YARRA CITY COUNCIL
Internal Development Approvals Committee
Agenda

1.1 PLN17/1061 - 93-97 Webb Street, Fitzroy - Part demolition and use and development of the land for the construction of a mixed use building (permit required for dwelling use) and a reduction in the car parking requirements.

1. This report provides an assessment of planning permit application PLN17/1061 and recommends approval, subject to conditions. The application proposes the part demolition of the existing building and development of the land for a 7 storey building (plus 2 levels of basement levels with 22 car spaces) containing 16 dwellings and 1 office (158sqm) fronting Webb Street and nine (9) four (4) storey townhouses fronting the eastern laneway and Charles Street.

Attachment 1 - PLN17/1061 - 93 - 97 Webb St, Fitzroy - Decisions Plans - Part1.

300MM WIDTH & 700MM HEIGHT REDUCTION DASHED RED

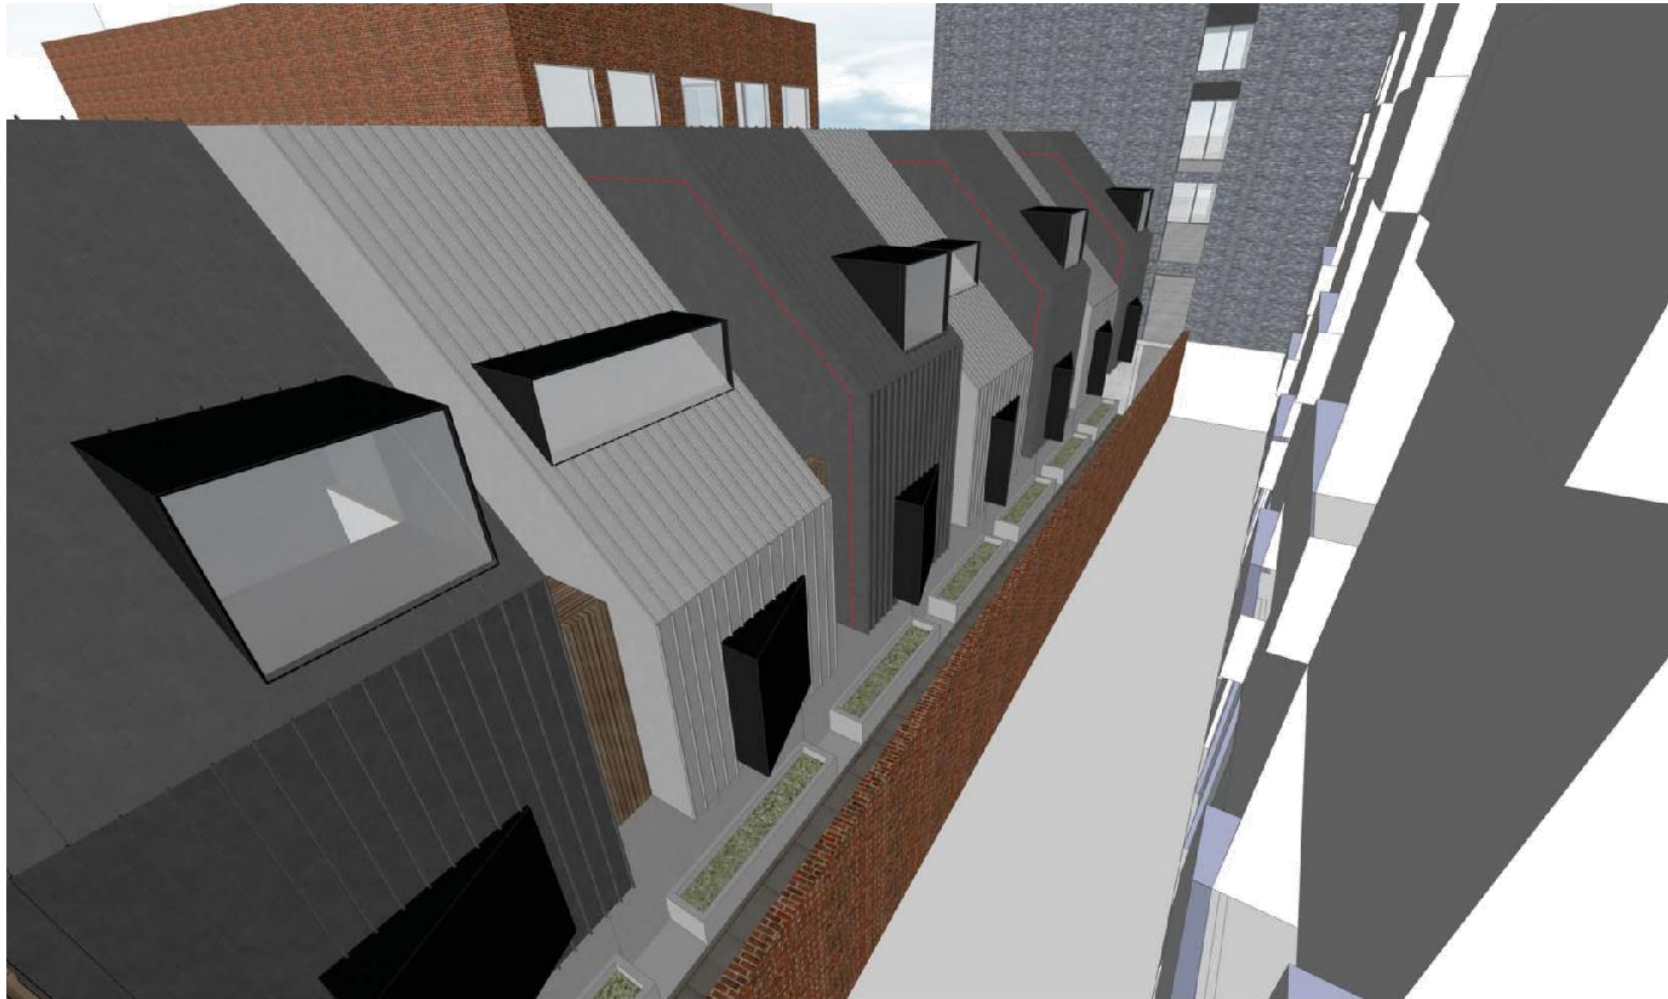
161. Finally, in relation to the height and setbacks, subject to the changes shown on the sketch plans the external urban design advice has supported the top two levels as follows:

- (c) *The amended plans have been refined to minimise the visibility of the upper levels from the street. It has done so by trimming the previous jagged corners of the upper levels, which accentuated the mass and juttied out above the mid-rise section of the proposal. In this midblock context, the presentation of the 'base' should be more dominant which will reinforce the anticipated urban hierarchy and legibility of the centre. The profile of the upper levels also draws people's eyes down towards the lower levels –which is a positive (as demonstrated below). We consider this is an apt response within the Smith Street Activity Centre...*

PERSPECTIVES
TOWNHOUSE AERIAL VIEW FORM REDUCTION

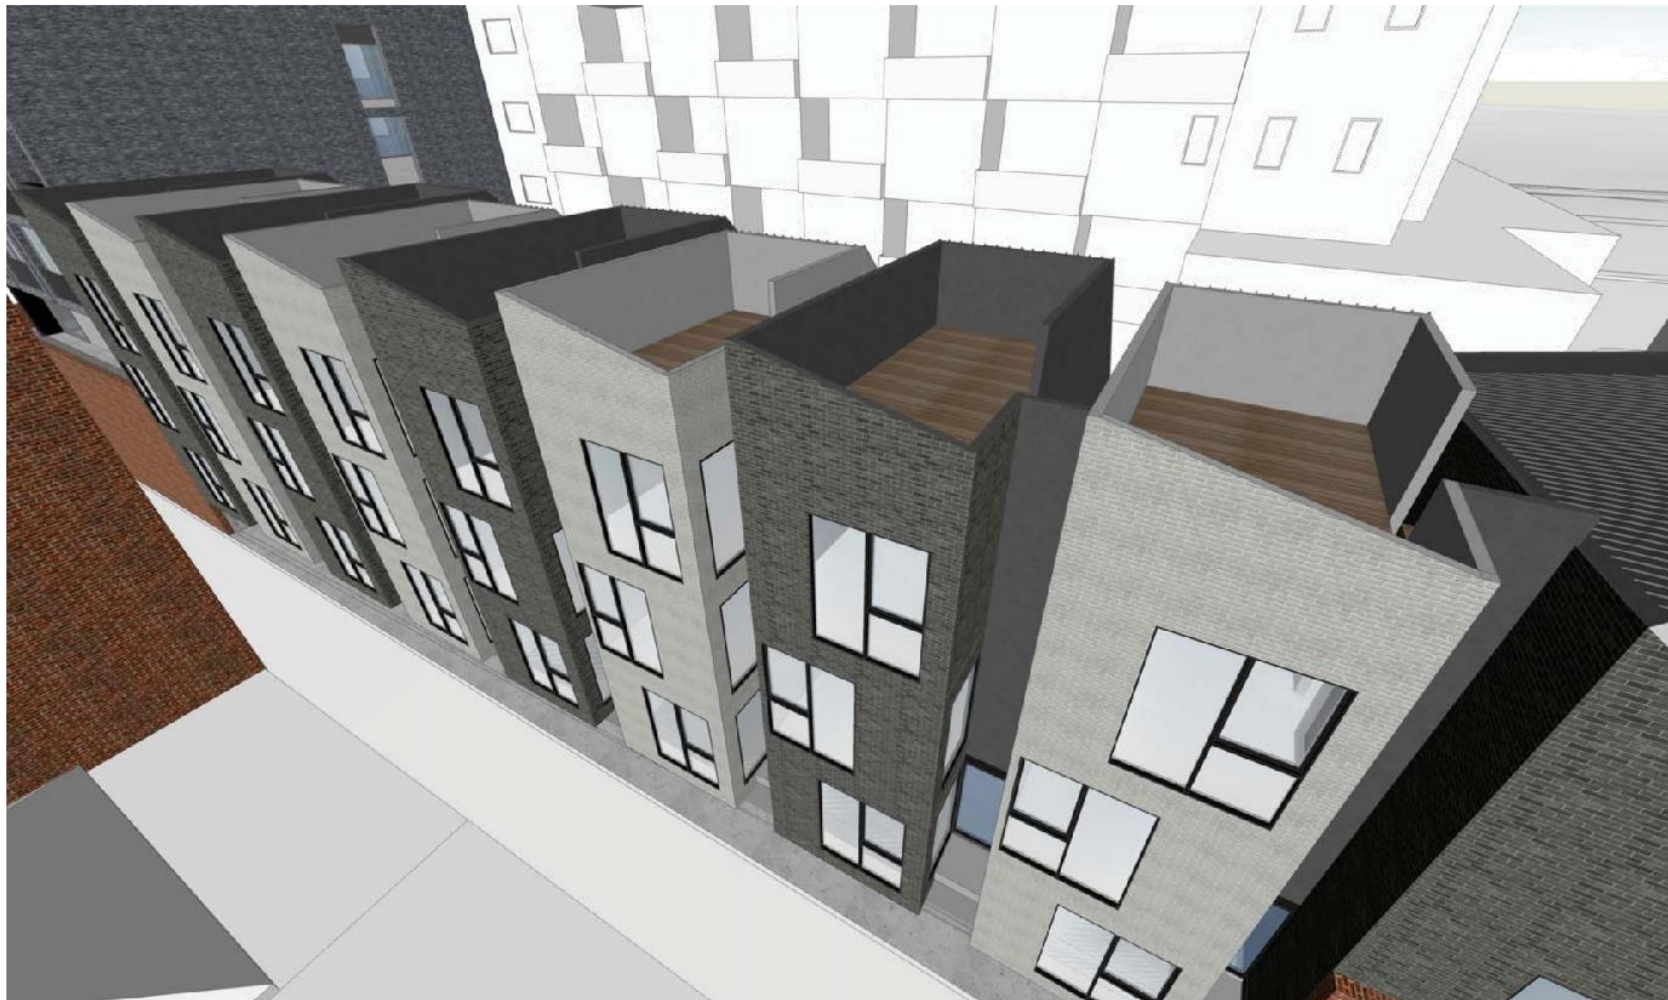
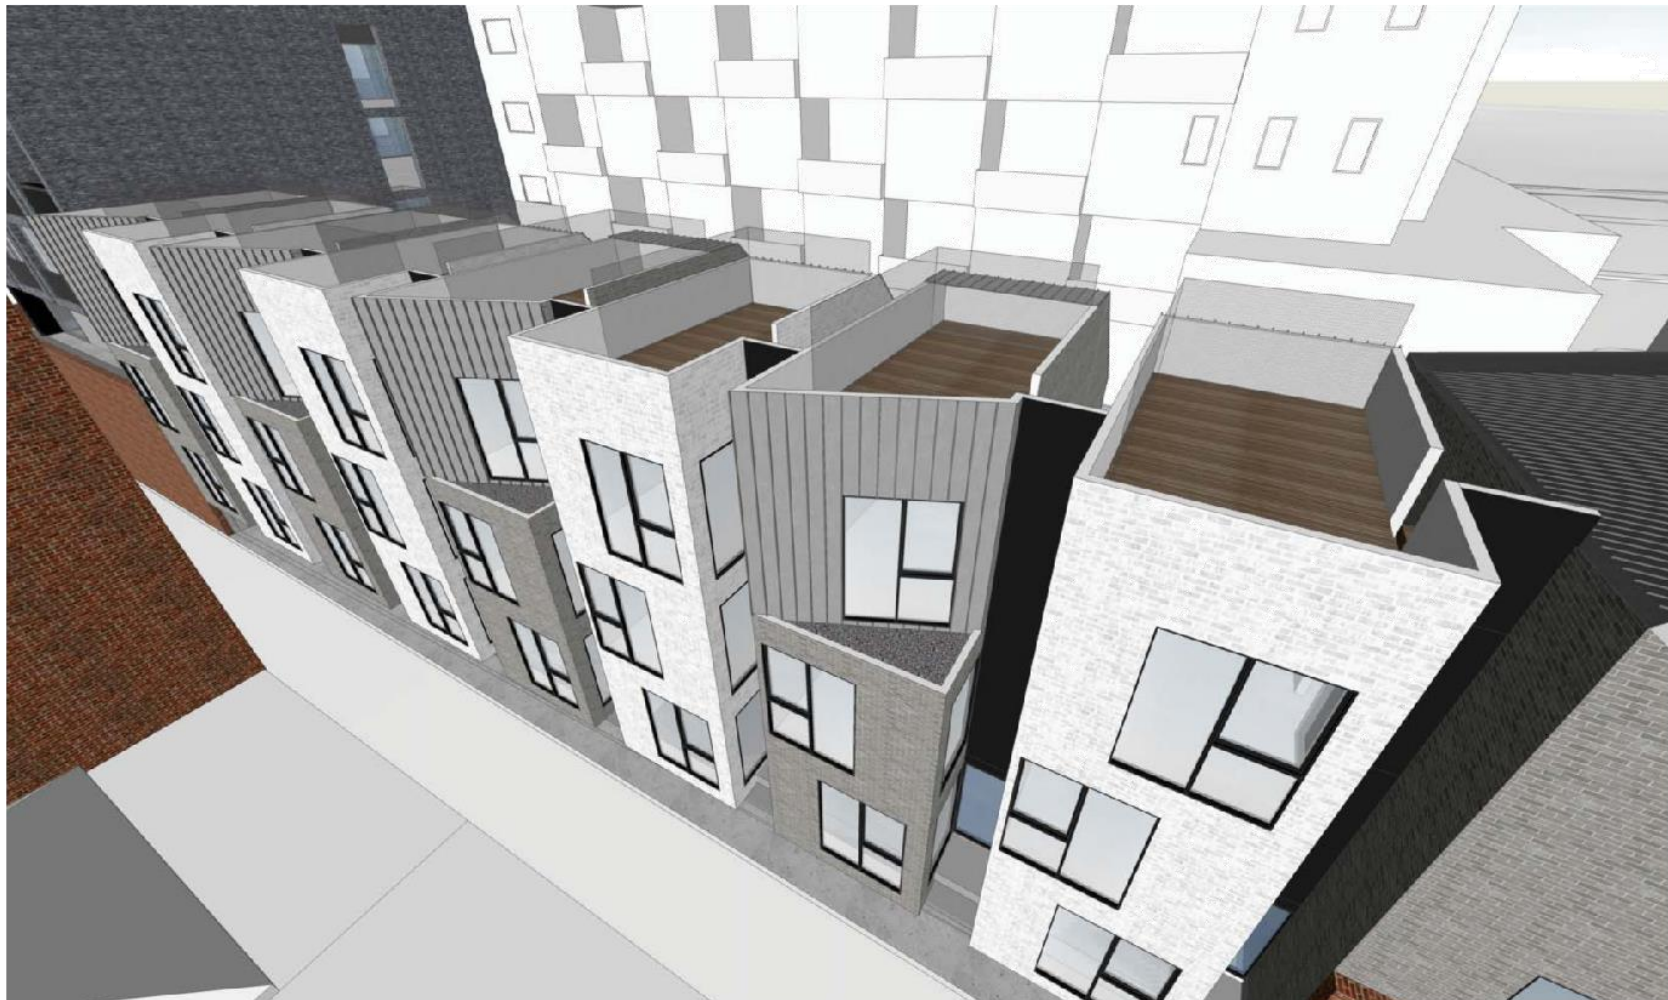
151. This is further supported by the fact the urban design and heritage design advice did not request changes to the proposed townhouses, apart from the urban design advice seeking overlooking screens to be reduced in height to improve outlook to the west. In response to this advice the previously solid overlooking screens have been replaced with perforated metal. This will improve the sense of space and outlook of the terrace while also addressing overlooking concerns (subject to detail of the screens being provided). Finally, the sketch plans provide further setbacks from the east and west boundary and a reduced height, mitigating any concerns relating to the scale and massing of the townhouses.

APARTMENT FORM REDUCTION
LEVEL 5-6

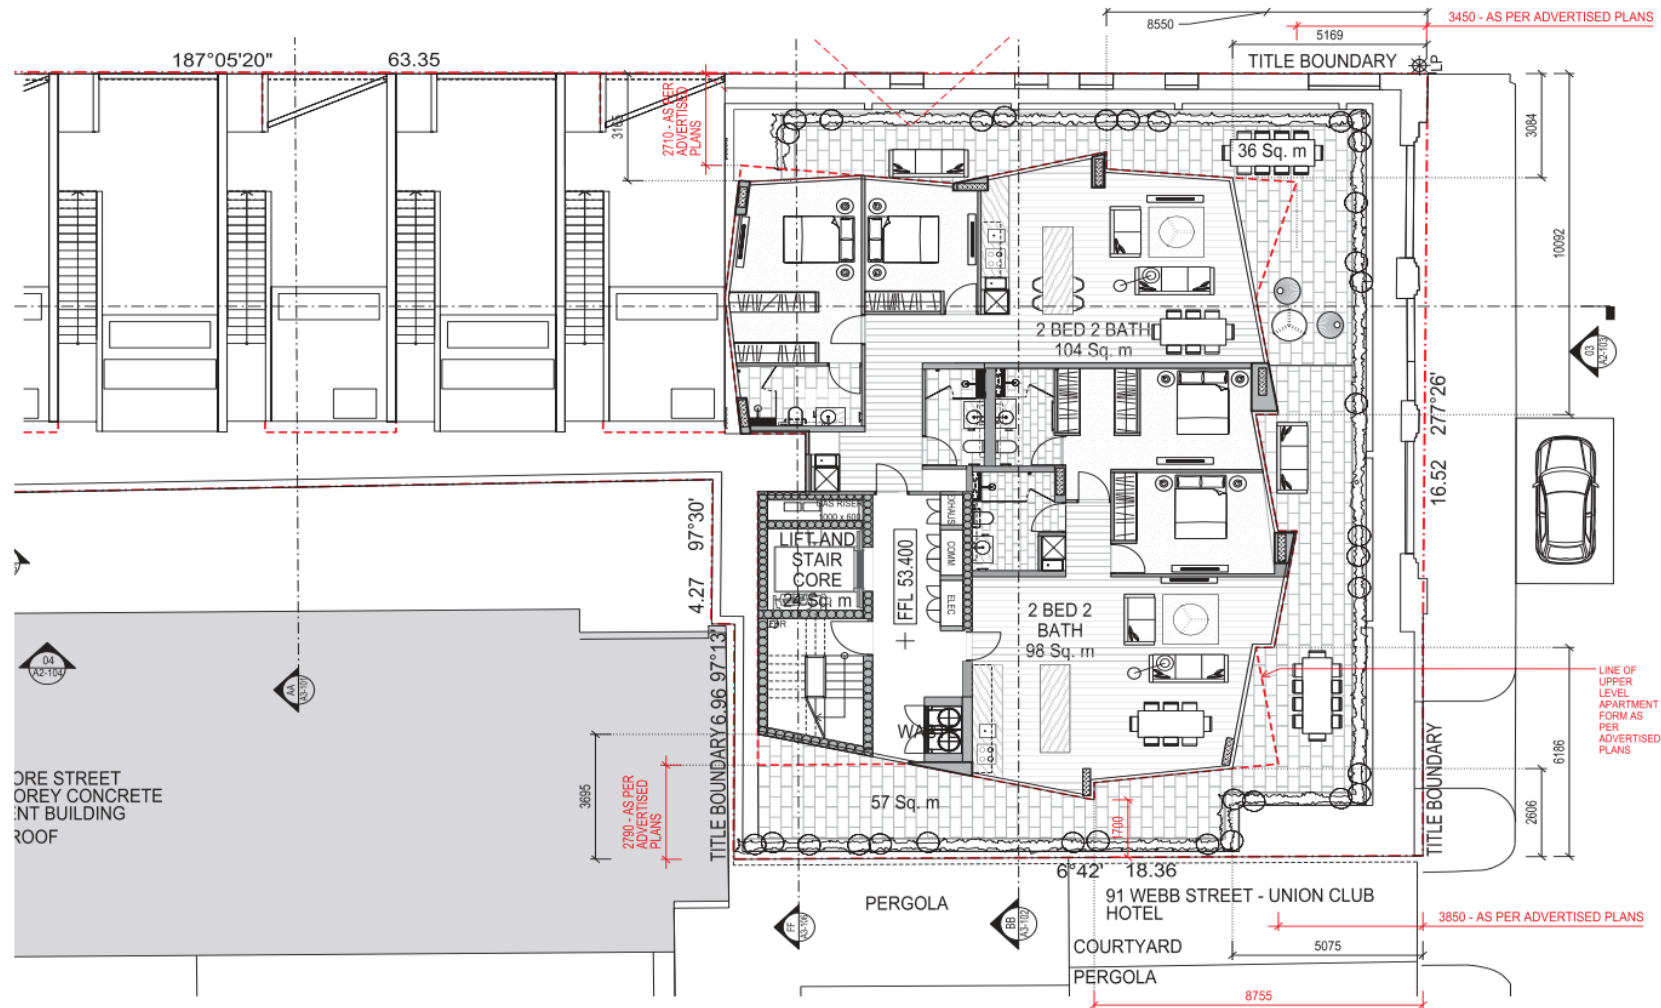
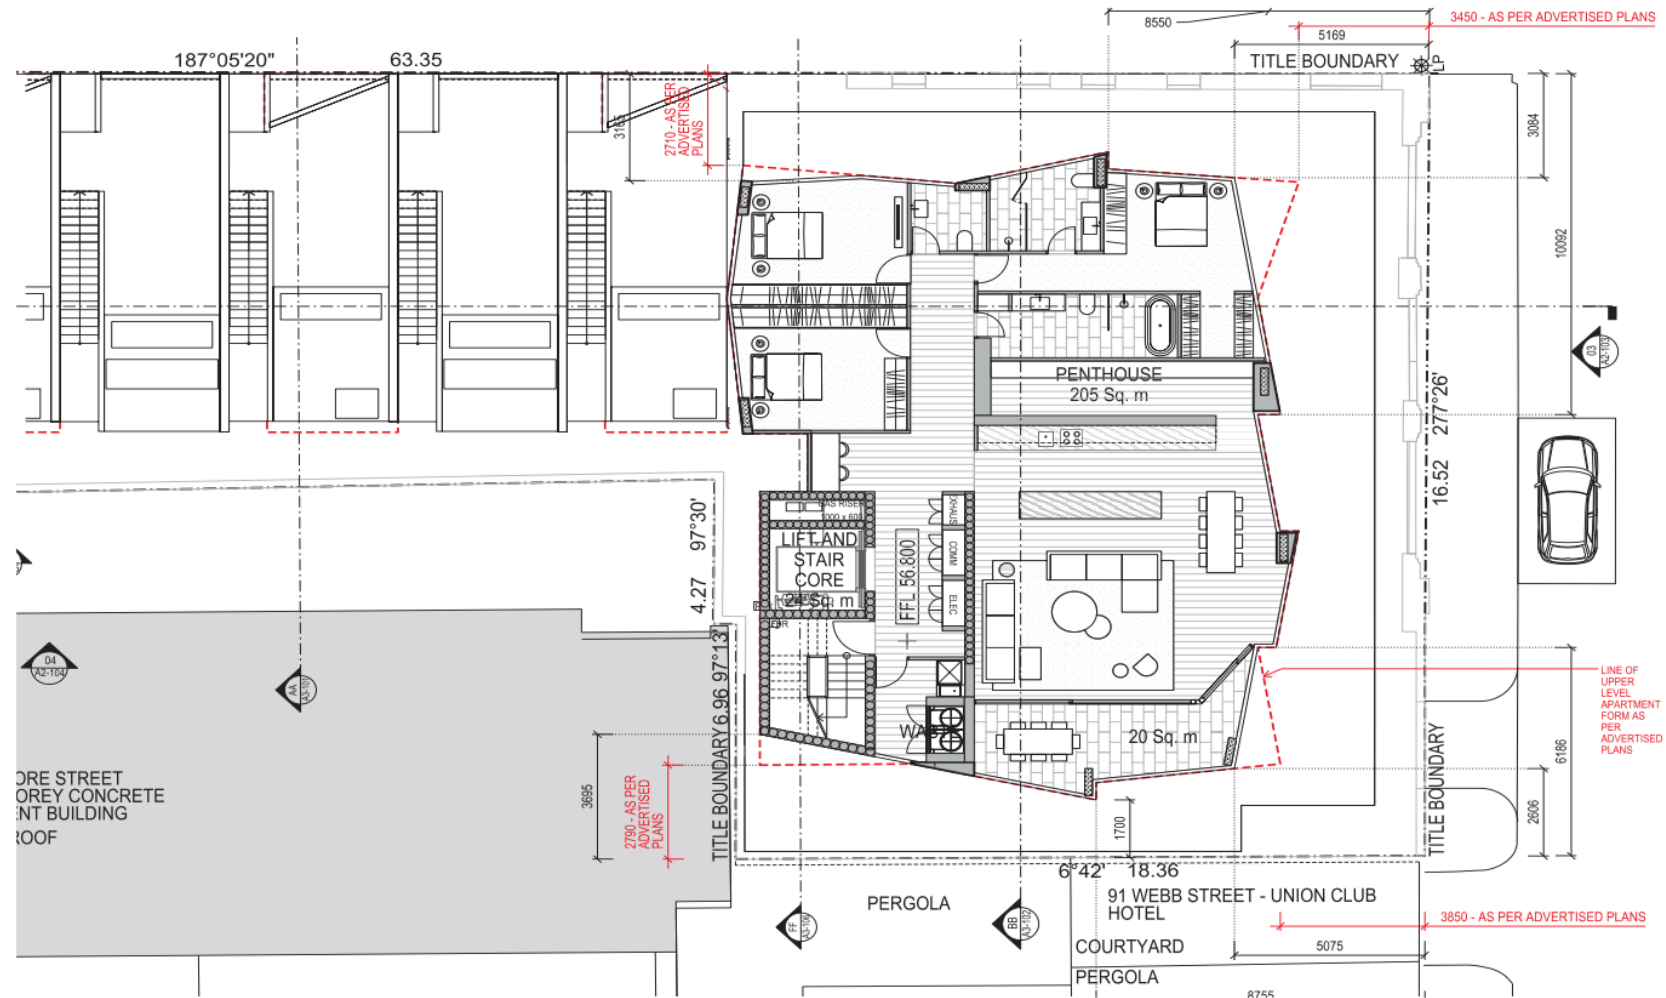
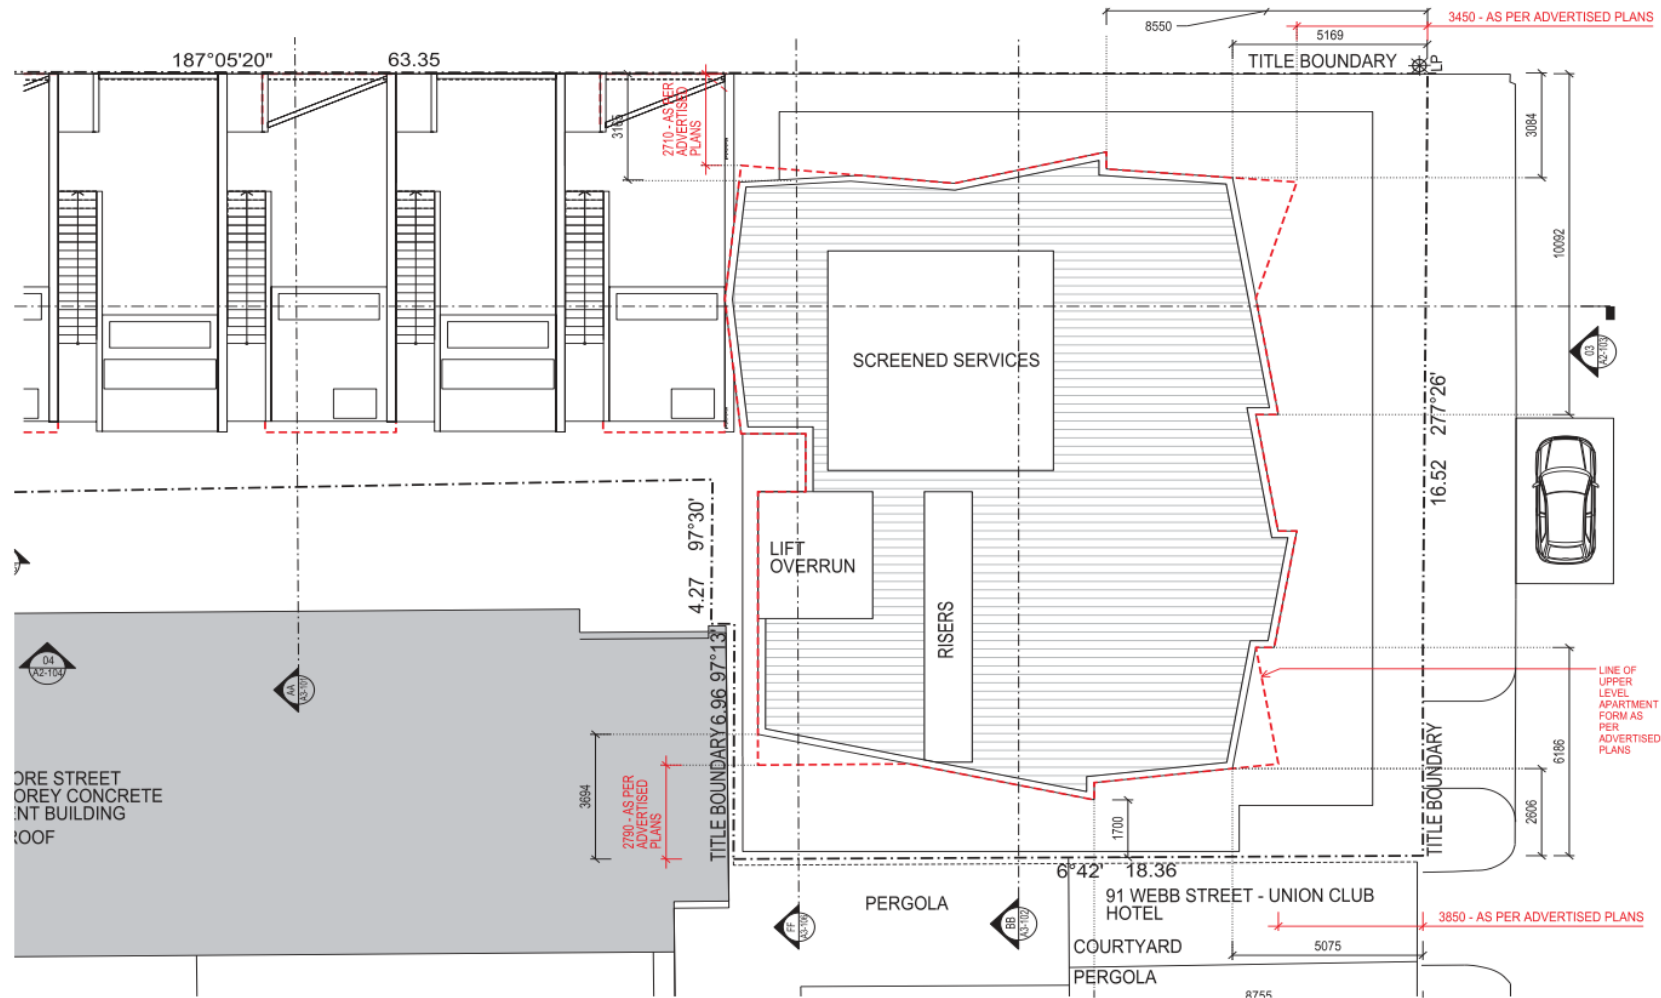
165. As mentioned earlier, the increased setback to floor 5 and 6 have been supported by the urban designers. Further they, along with Council's heritage advisor recommended the western boundary wall be a lighter colour. This change has been adopted in the sketch plans although there is nothing to break up the mass. The heritage advisor requested that floor 1-4 to Webb Street and the front wall of townhouse 9 be a red brick finish complimenting the red brick on the existing façade. However, policy discourages mimicking heritage fabric so it is considered better to contrast the brick colour so that the new addition is clearly distinguishable as non-original heritage fabric, a design approach that is specifically encouraged by clause 22.02. The lighter colour shown in the sketch plans is less of a stark contrast and so will sit more comfortably with the heritage fabric and will be required by way of condition.
